# Access Compliance Report

## Public Rights-of-Way

Intersection ID: 10033468	Main Street: OLD_PINEVILLE_RD	Cross Street: N/A	Location: SW
ADA ID: BF88E31BB79C	Ramp Type: PerpDiag	Initial Pass/Fail: Fail	Overall Compliance: No
Severity Score: 10			
Codes/Mitigation Info/Possible Solution		Field Measurements/Component Compliance

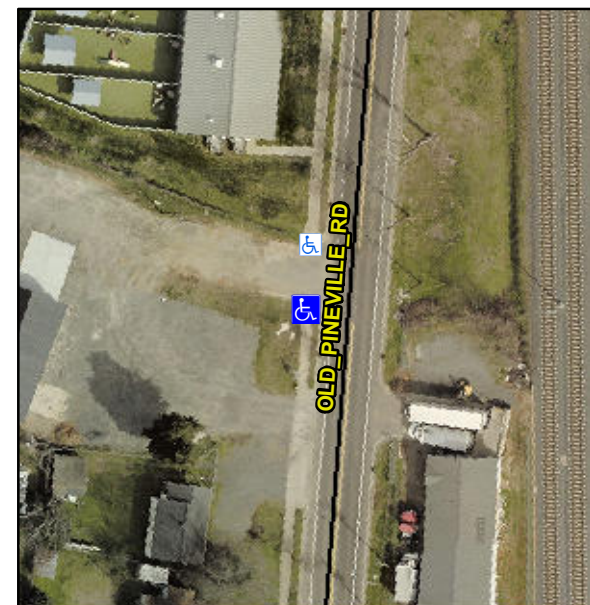
**Not Found, R304.5.1**

Compliance	Description	Data	Compliance	Description	Data
N/A	Ramp Length (in)	54.0	Yes	Ramp Slope (%)	5.2
No	Ramp Width (in)	47.0	Yes	Ramp XSlope (%)	2.2
N/A	Flare Type LT	N/A	N/A	Flare Type RT	N/A
N/A	Flare Slope LT (%)	N/A	N/A	Flare Slope RT (%)	N/A
N/A	Flare Traversable LT?	N/A	N/A	Flare Traversable RT?	N/A
N/A	Landing Length (in)	N/A	N/A	DWS Provided?	N/A
N/A	Landing Width (in)	N/A	N/A	DWS Contrast?	N/A
N/A	Landing Slope (%)	N/A	N/A	DWS Length (in)	N/A
N/A	Landing X Slope (%)	N/A	N/A	DWS Full Width?	N/A
N/A	Landing Curb? (Y/N)	N/A	N/A	DWS Offset (in)	N/A
N/A	Shared Landing?	N/A			
N/A	Gutter Ponding?	N/A	N/A	Gutter Slope (%)	N/A
N/A	Gutter Lip Ht (in)	N/A	N/A	Gutter X Slope (%)	N/A
N/A	Painted X Walk1?	No	N/A	Painted X Walk2?	No
	X Walk 1 Direction	To E		X Walk 2 Direction	To N
N/A	X Walk 1 Width (in)	N/A	N/A	X Walk 2 Width (in)	N/A
	X Walk 1 Slope (%)	0.6		X Walk 2 Slope (%)	1.9
	X Walk 1 X Slope (%)	0.5		X Walk 2 X Slope (%)	2.8

**Remove & Replace Curb Ramp With Two New Directional Ramps or Equivalent.**
